ADDENDUM NO. 3

Date February 18, 2025

Kelso School District

Coweeman Middle School Cladding Replacement

R113

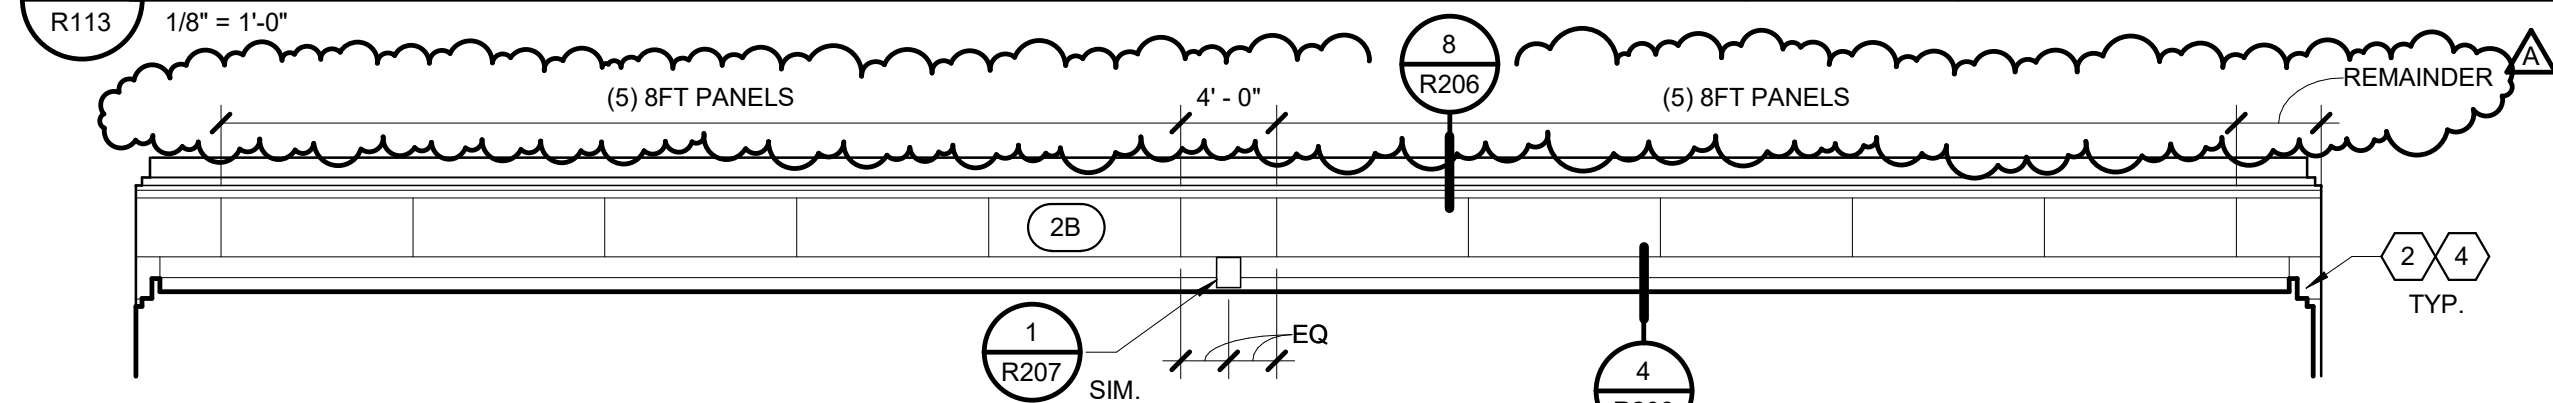
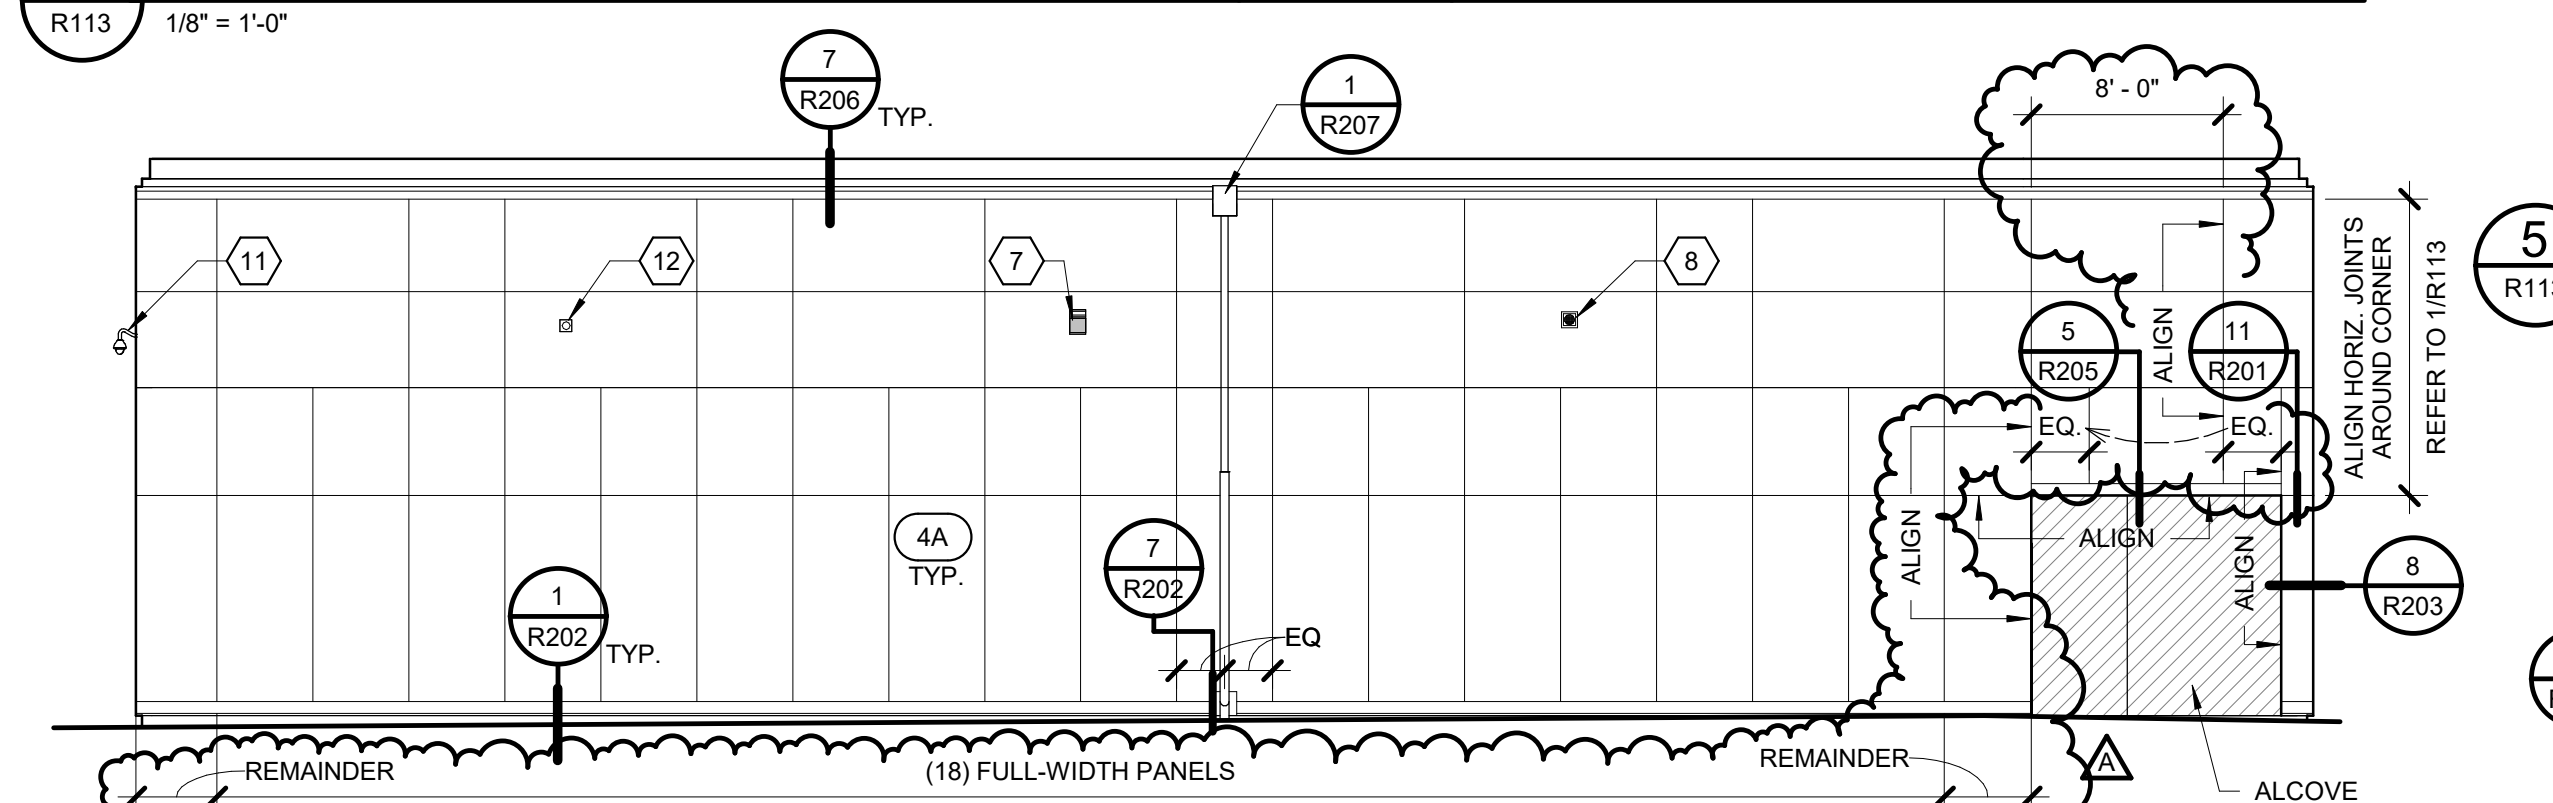
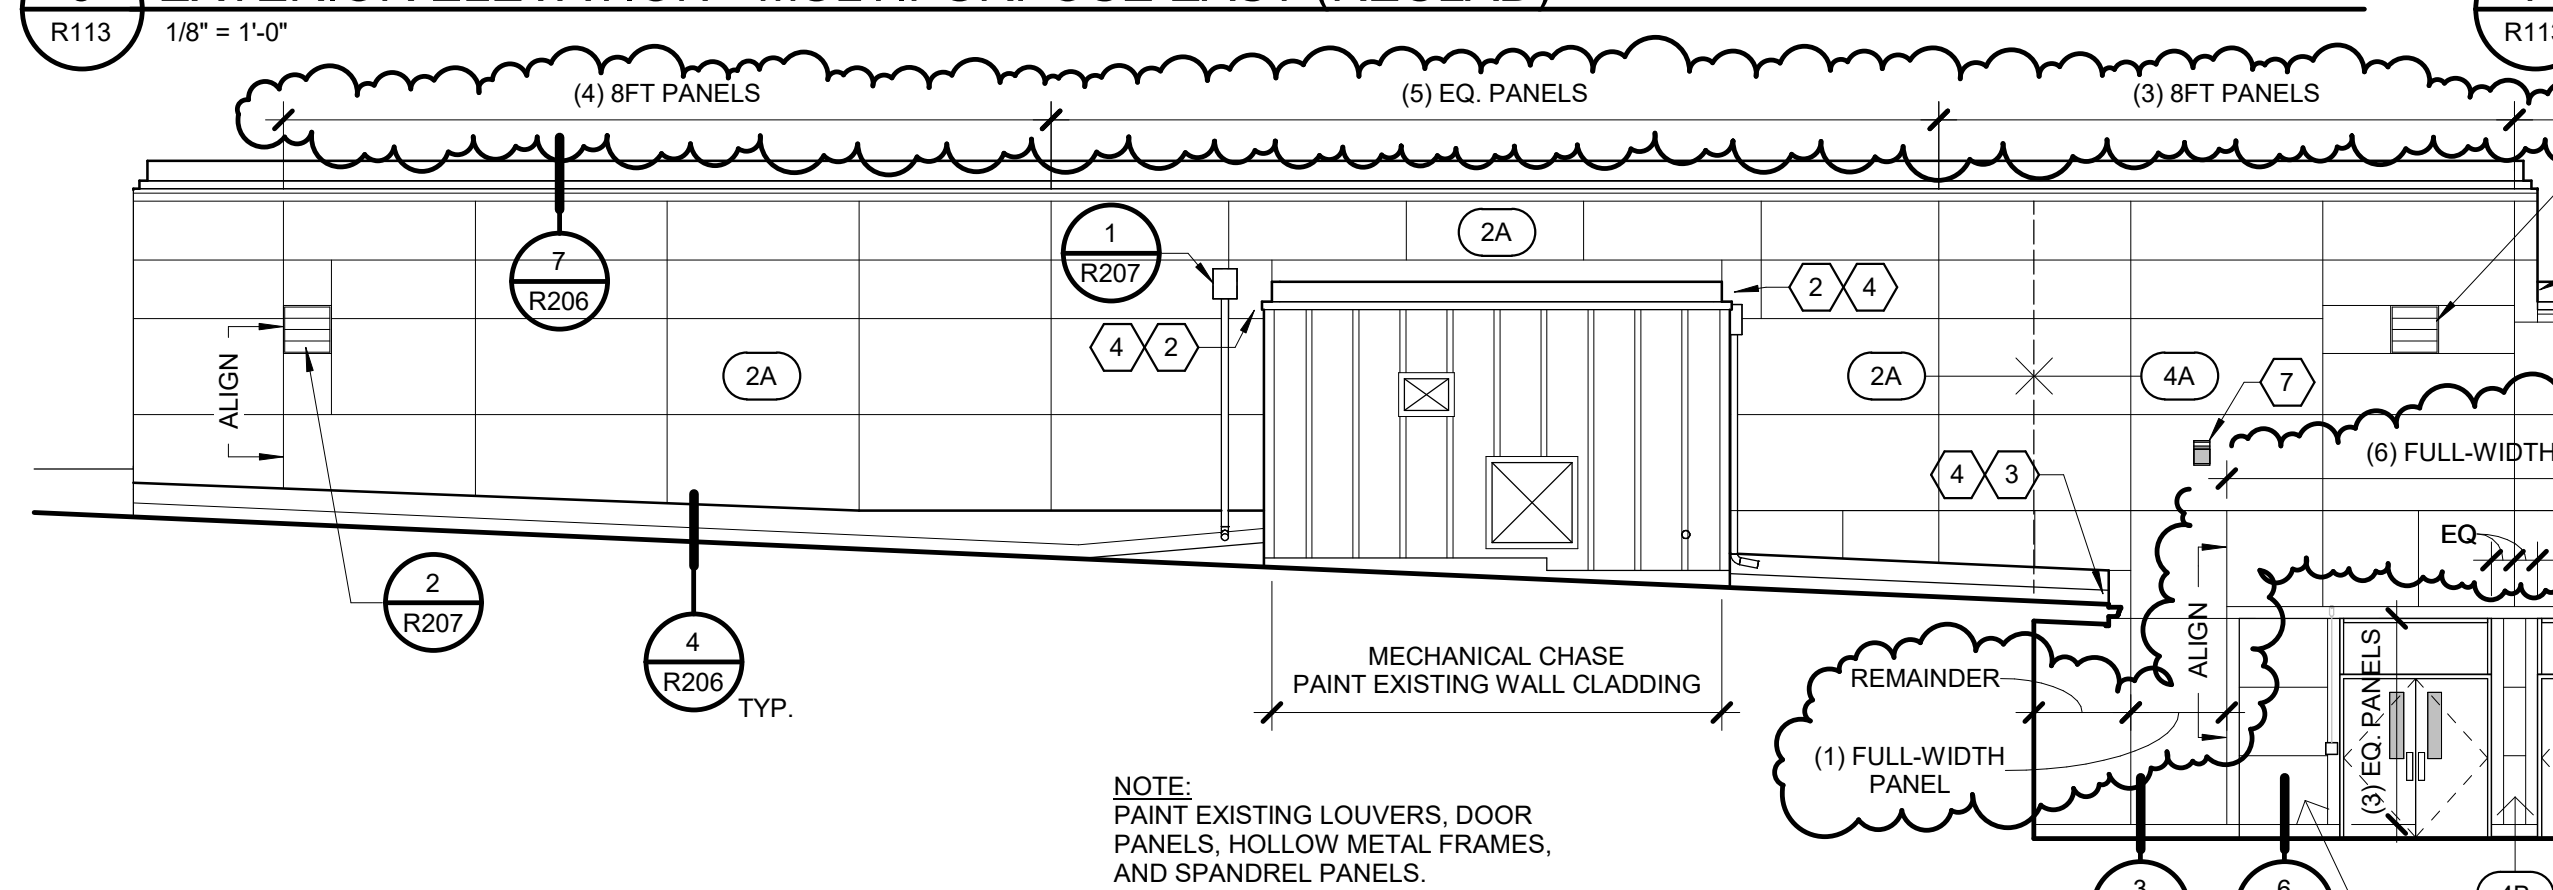
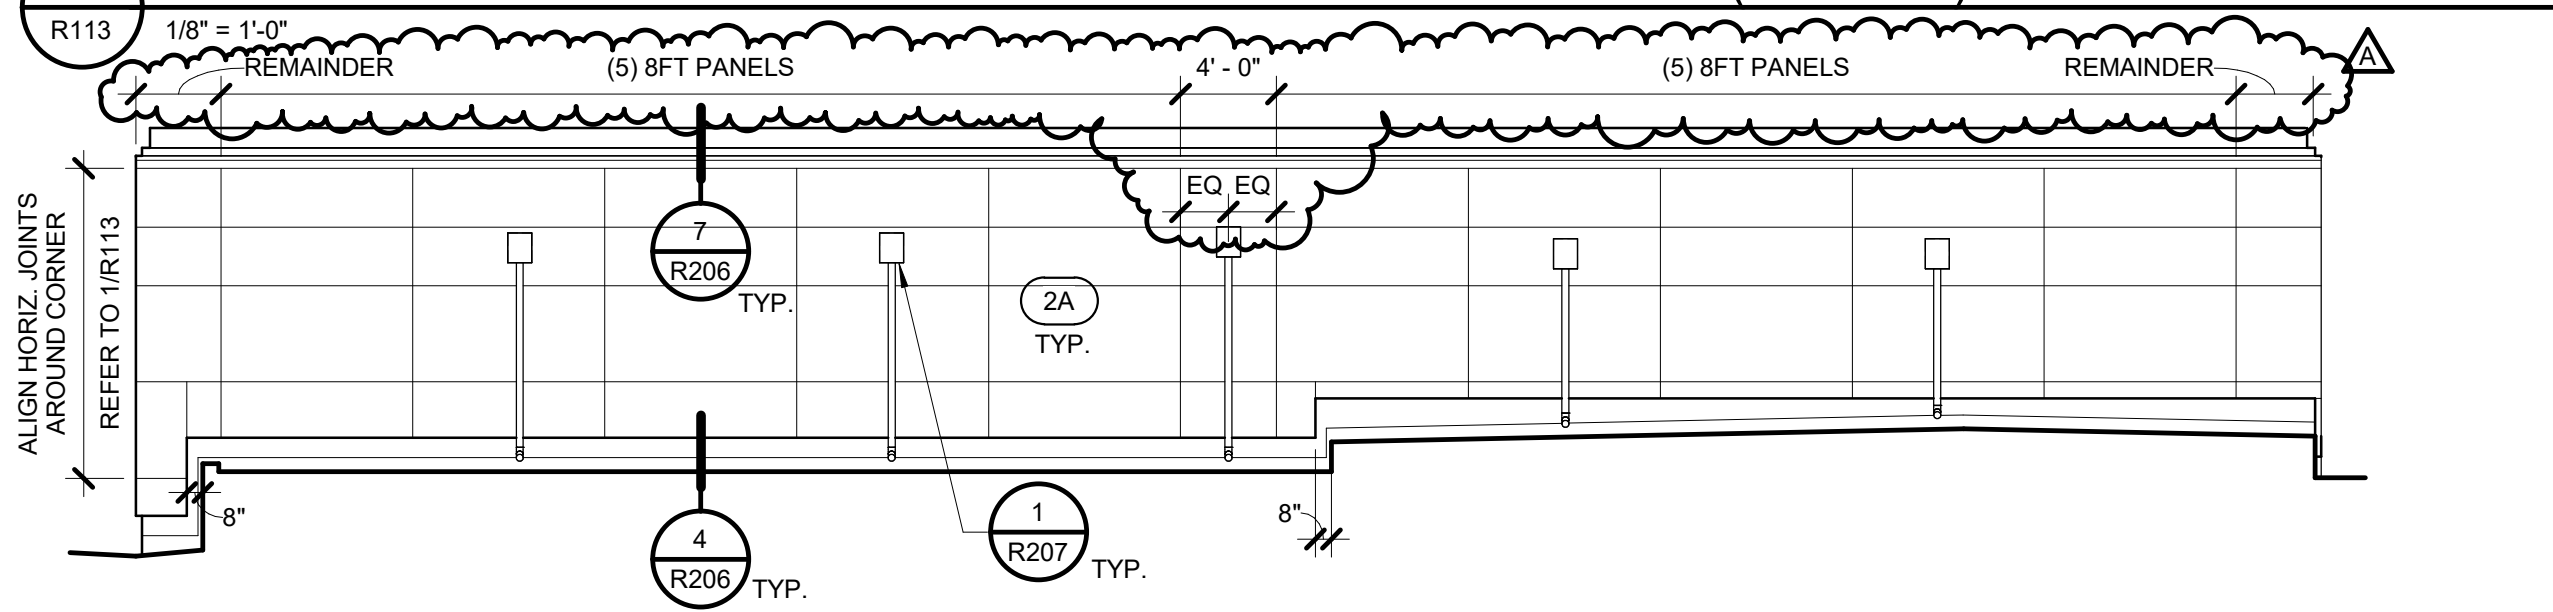
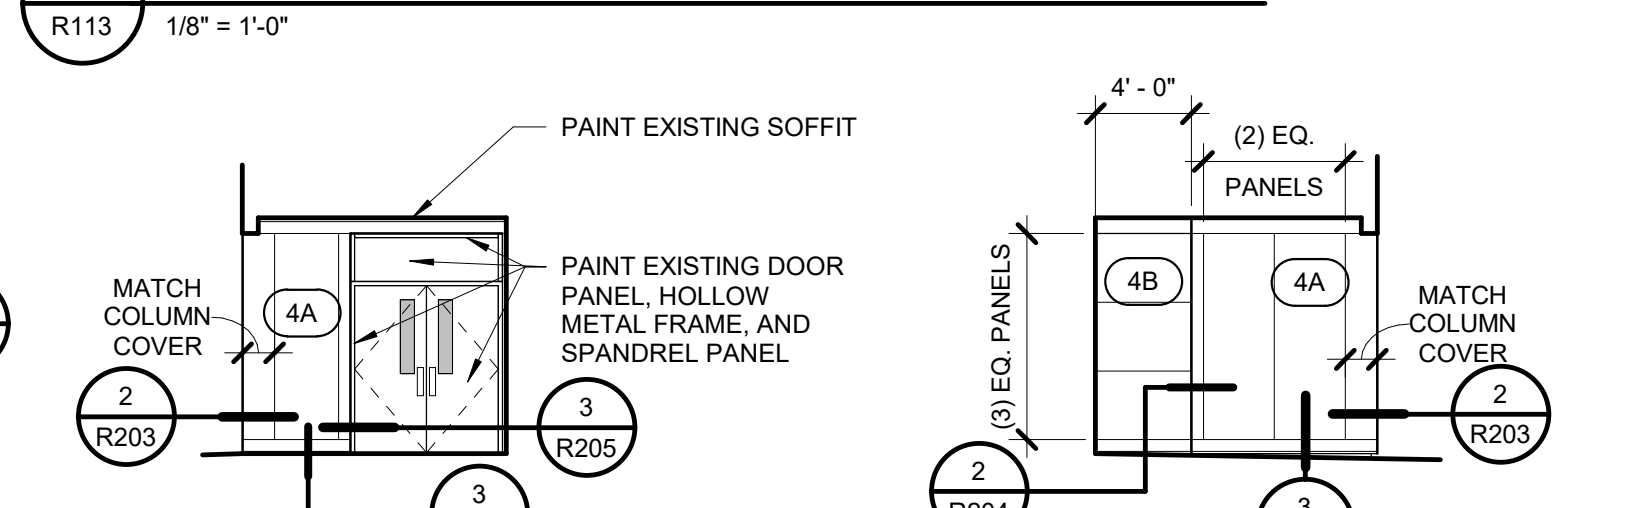
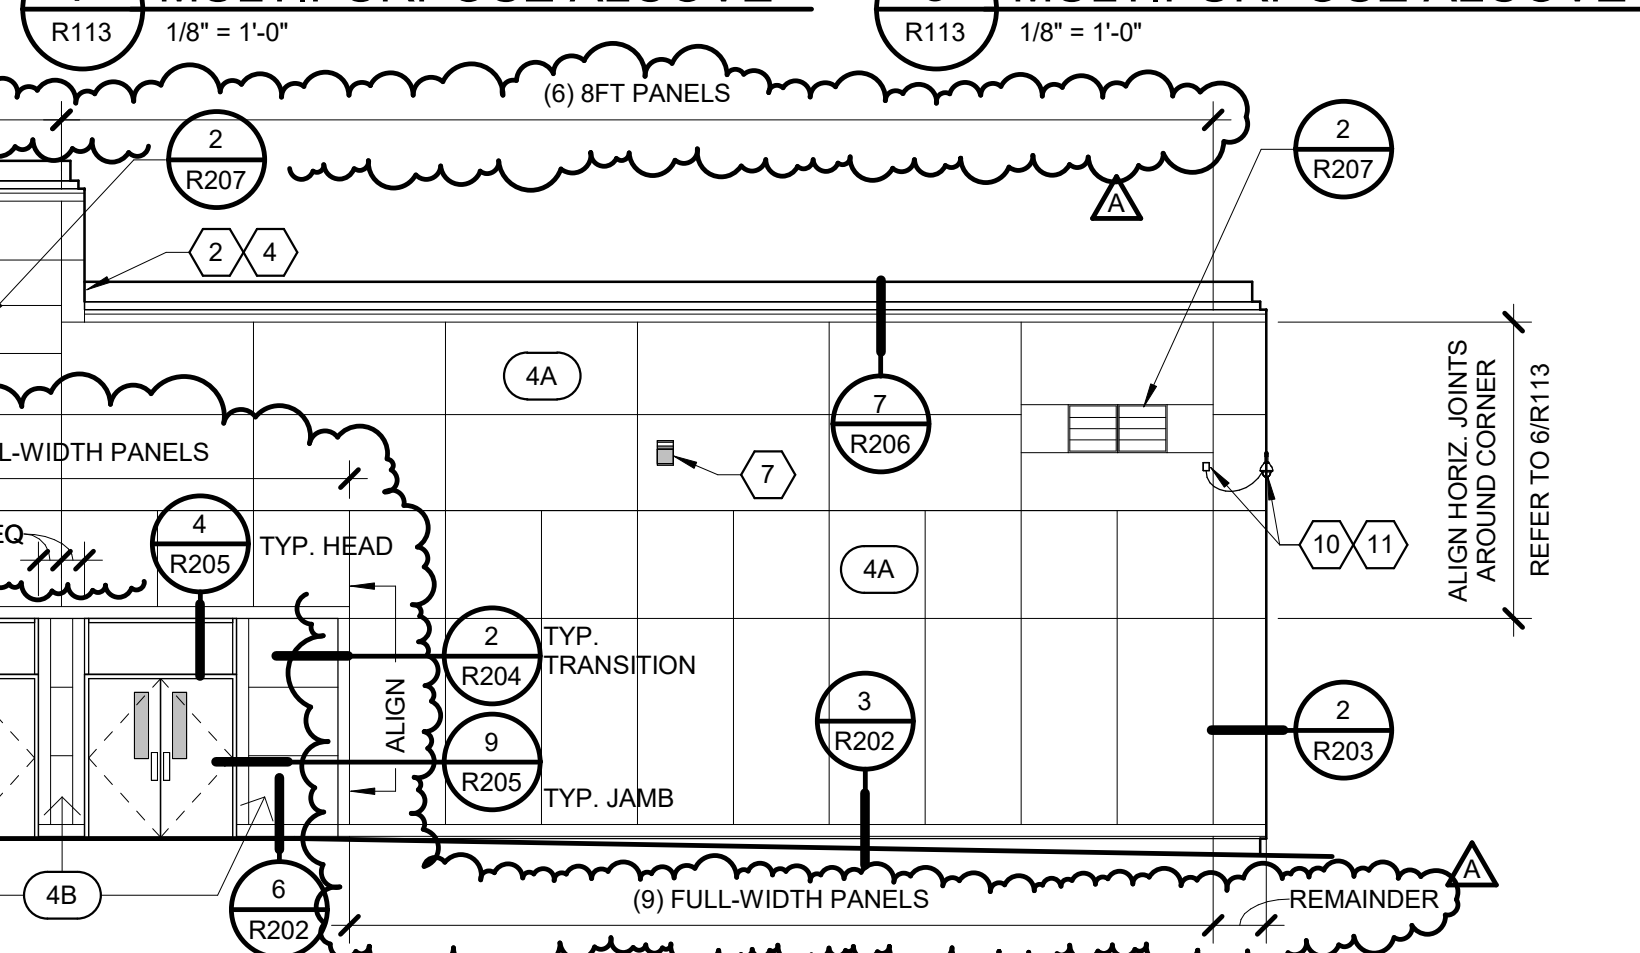
3.03	<i>Drawing Sheet R113</i>	Replace sheet with attached revised Sheet R113. Note the following changes: <ul style="list-style-type: none">• Altered layout of fiber cement panels to reduce the need for cutting panels to custom widths.• Added Addendum No. 3 revision identifier.
